PREESE HALL SHALE GAS FRACTURING

REVIEW & RECOMMENDATIONS FOR INDUCED SEISMIC MITIGATION

We have been asked by DECC to review these reports, and the further studies and information provided by Cuadrilla; and to make appropriate recommendations for the mitigation of seismic risks in the conduct of future hydraulic fracture operations for shale gas.

Figure 1: Graphs showing a) variations of analysed parameters with depth and b) overlay prefrac surface treating pressure plots.

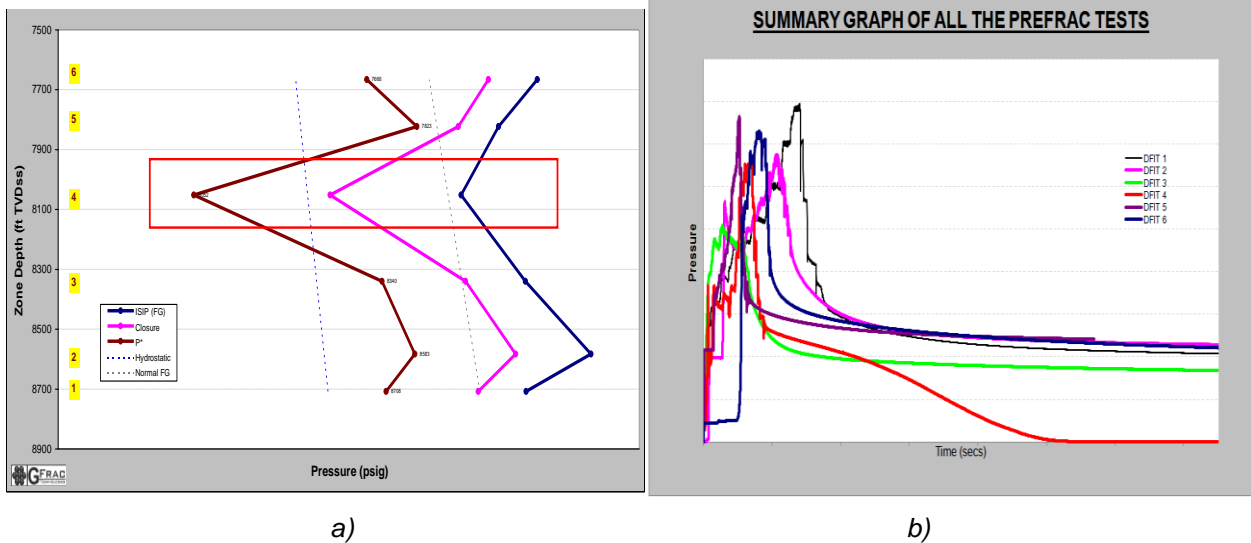
The plots of the treatment variations with depth are shown in Figures 1a) and 1b) and the only obviously exceptional zone is zone 4, as highlighted in Figure 1a. Zone 4 prefrac injection test analysis indicates that the fracture grew into a much lower stress zone and exhibited "fracture height recession" type leak-off characteristics, here probably representing the created fracture being forced into high-stress impermeable layers, which are forced to close first. We interpret this as possibly being at, or very near, to the fault, which is then proposed as a possible explanation of the subsequent immediate seismic events, while injecting into zones 4 and 5.

Overall, the results indicate distinct and separate behaviours for each zone, interpreted as being representative of good containment of the created fracture growth in each zone. However, we consider that there is little additional useful information that can be concluded about the resultant fracture growth using only the surface job data, given the lack of complementary diagnostics.

Figure 3: Woodford shale measured fracture heights compared to aquifer depths (copyright SPE)

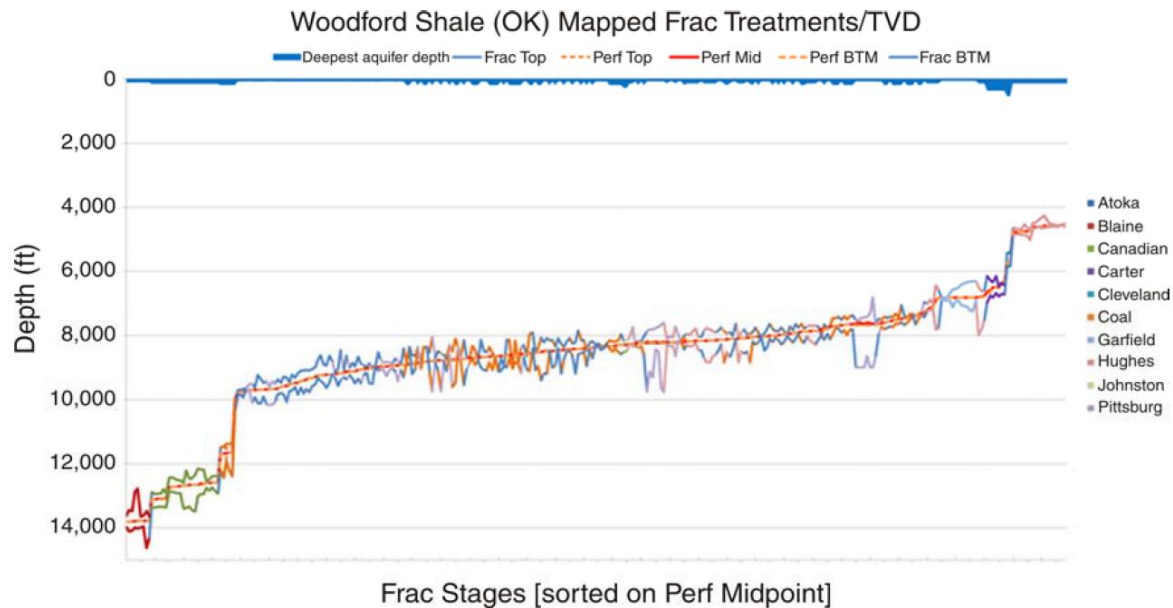
One of the major concerns with shale gas developments is answering the question of how the created hydraulic fracture grew, particularly in relation to shallower aquifers. A summary of US microseismic and tiltmeter data in shales has recently been published (Fisher and Warpinski, 2011) based on treatments carried out in the Barnett, Woodford, Marcellus and Eagle Ford shales. This work is of particular interest as it summarises how the fractures grew with respect to the overlying aquifers. Overall, the data indicate that in general for deeper shales (here classified as >4000ft TVD_{SS}), the created hydraulic fractures remain well confined to the target interval, even in the presence of faults, (see Figure 3 and also Figures 4-6).

Overall, the US data indicates that faults do not provide a mechanism whereby created fractures are able to propagate significantly upwards, towards the surface. The presence of faults is generally indicated by large upward and downward growth spikes, but overall vertical growth is still limited to several hundreds of feet. The Woodford shale is probably the best analogue for the Bowland shale, as it also has a very complex geology which also includes faulting and highly dipping or overturned bedding planes. However, interpretation of the

Woodford, in common with the Barnett, shows that created hydraulic fracture heights are well contained and separated from the local aquifers by at least several thousand feet. (In US regulatory practice, the focus would be on protection of aquifers used, or potentially usable, for drinking water supplies. It is our understanding that in the UK, the Environment Agency would aim to secure appropriate protection of all groundwater.)
